**Technical Memorandum
Review of the Proposed Montanore Mine
Supplemental Draft Environmental Impact Statement
and
Supporting Groundwater Models**

**Prepared for Save Our Cabinets, Earthworks, and the Clark Fork Coalition
December 15, 2011**

**Prepared by:
Tom Myers, PhD
Consultant, Hydrology and Water Resources
6320 Walnut Creek Road
Reno, NV 89523
tom_myers@charter.net**

Figure 1: Snapshot from SDEIS Figure 76 showing monitoring points for flow in the streams.

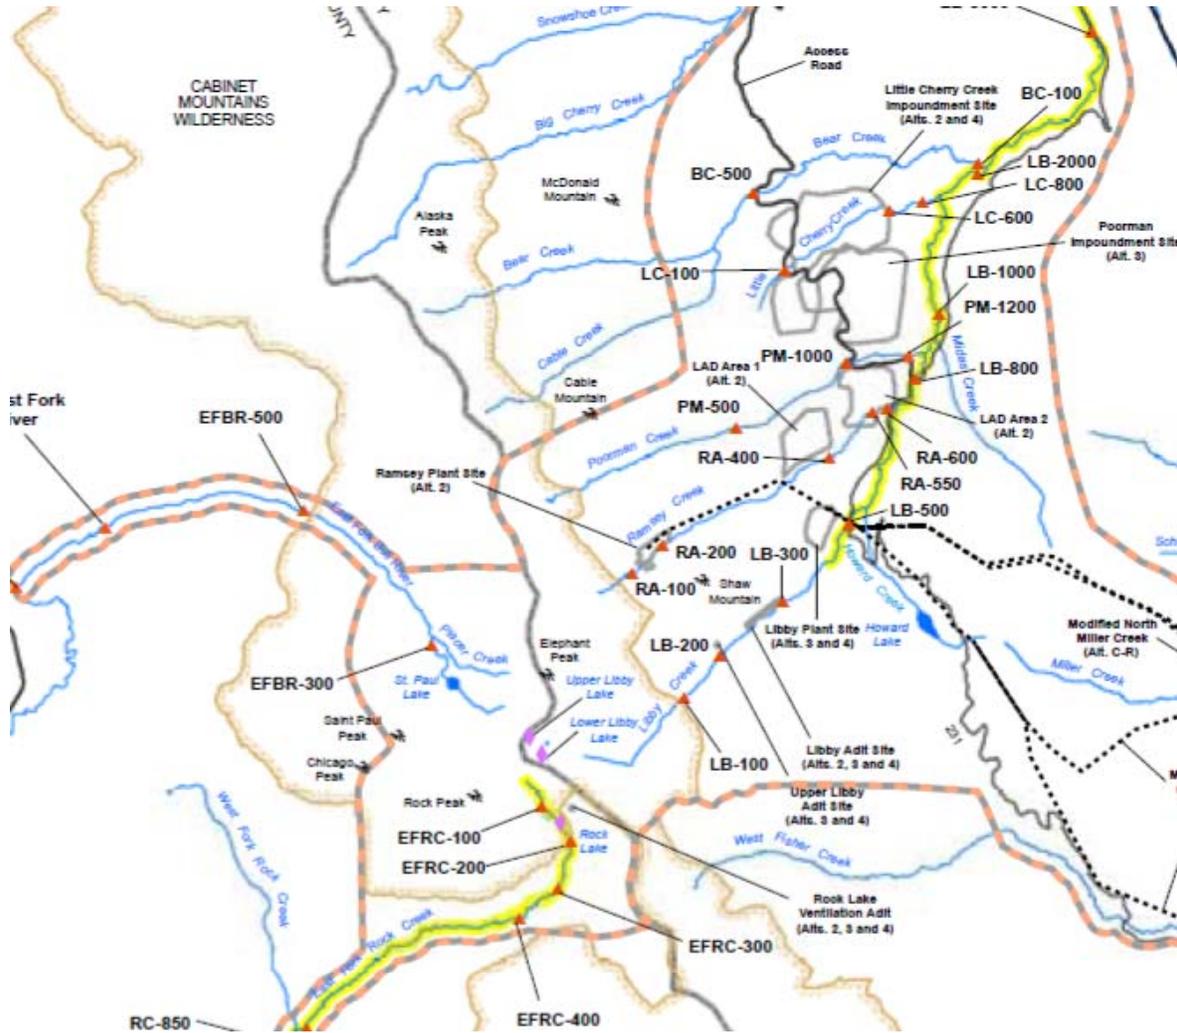
Tables 94 through 97 provide the absolute and percent reductions (or increases) in streamflow at various model monitoring points compared with the calculated low flow values (Figure 1). During the construction phase, Libby Creek LB-300 experiences 27 and 79 percent flow increases due to discharge of dewatering water. During operations, the drawdown effect overcomes the discharge and the LB-300 site experiences 6 and 18 percent flow reductions, respectively. The biggest decreases are at the East Fork Rock Creek site, EFRC-200 which have 9 and 21 percent flow reductions. This site is outflow from Rock Lake (Figure 1). During the closure phase, EFRC-200 experiences 26 and 62 percent reductions, respectively, for the 2- and 10-year return interval (Table 96). LB-300 has flow increases of 26 and 74 percent due to discharge of dewatering water. The effect of changes from the operations phase to the closure phase become obvious then with the EFRC-200 site being reduced by 41 and 100 percent at the

2- and 10-year return interval periods (Table 97); LB-300 would have experienced some recovery by this time with water levels rising from the simulated plugging of the Libby Adit.

Figure 2: Snapshot from Geomatrix (2011) Figure 36 showing the location of the Montanore and Rock Creek Mine void, and cumulative drawdown for 16 years after the end of mining.

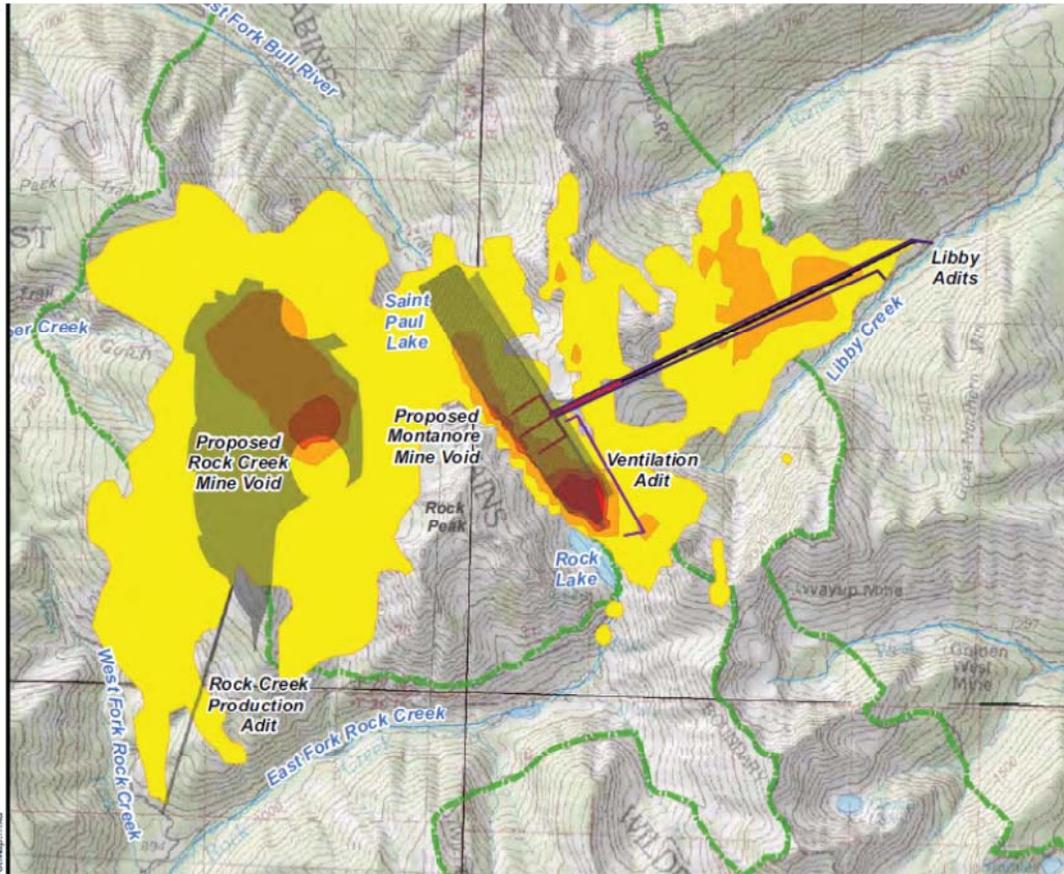
Cumulatively, operating the Montanore and Rock Creek Mines concurrently would affect flow in the East Fork Bull River and Rock Creek more than would either mine individually. However, comparison of

Tables 97 and 102 show that most of the impact comes from the Montanore Mine, because the cumulative decrease at EFBR-500 is 1 and 2 percent more for the 7Q2 and 7Q10 flows without mitigation and 1 and 3 percent more with mitigation; at RC-2000 is 1 percent more for the 7Q2 without mitigation and the 7Q10 with mitigation. This reflects the fact that the Rock Lake fault directly underlies the upper reaches of these two streams and that the modeling, with all of its assumptions, of the Montanore project affects water levels in the fault more than does the Rock Creek Mine. The mines are about 6000 feet apart (Figure 2).

Figure 3: Snapshot from Geomatrix Figure 27.

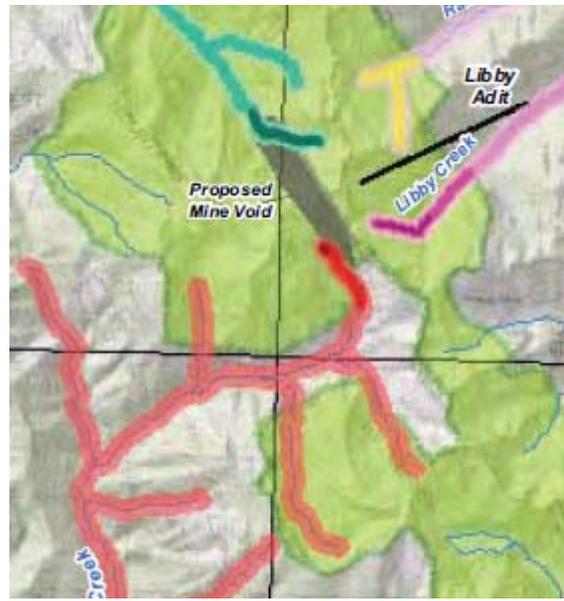
The largest impacts, relative to flow rate, will occur to upper reaches of Rock Creek, Libby Creek, and East Fork Bull River. Figures 3 and 4 are snipped from Geomatrix Figures 27 and 33, respectively, which should be referred to for the legends. Figure 3 shows the Rock Creek EFRC-50 and Rock Creek at Wilderness Boundary in darker red, Libby Creek at wilderness boundary in darker purple, and the East Fork Bull River in dark green. These, and the other reaches and other streams, have been modeled as transfer boundaries with the discharge to them controlled by gradient and a conductance (which the report does not specify) in model layer 1. These could be calibrated to flows estimated for these streams. The mine is in model layer 6, so the drawdown must propagate through five layers to affect the streams by inducing recharge from or reducing discharge to the stream. The vertical conductivity of these layers controls the rate at which the drawdown occurs. Baseflow changes occur when the gradient at the stream change; if the gradient changes from positive to negative, the stream will change from receiving discharge to recharging the aquifer. At high elevations where there is no baseflow, this could not occur since there would be no water in the stream to flow into the aquifer; recharge may occur from these streams during runoff periods.

The figures show clearly the simulated drawdown occurs directly under the reaches EFBR-300 and EFRC-50. The time of maximum impact is 16 years after mining ceases because the drawdown continues to expand as the mine void fills with water. EFRC-50 goes essentially dry but discharge to EFBR-300 decreases by less than 20% at this time; drawdown at EFBR-300 appears to range from 10 to 100 ft while at EFRC-50 it appears to exceed 100 ft. Not knowing the initial gradient, it is difficult to verify or even understand the modeled changes in flow; in particular, the gradient controlling flow to the upper end of the E Frk Bull River must initially be high if drawdown from 10 to 100 feet causes less than 20% flow reduction.
